Product / Process Change Notification (PCN)

PCN #: PCN_IndExB_20210401
Affected Series: WE-ExB-Series
 744844xxx S17100062

Spacer drawing for WE-ExB Series

Old drawing:

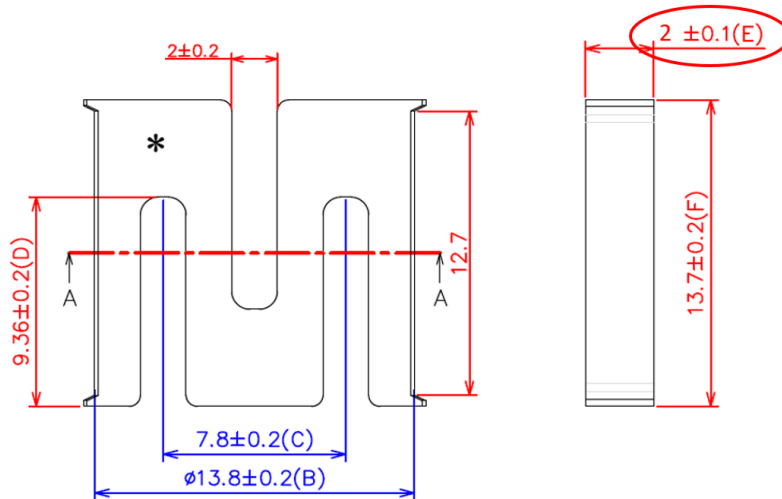
To assure assembling processability, Würth Elektronik will change the spacer thickness from currently 2 mm to 3 mm. For detailed information, refer to following drawings.
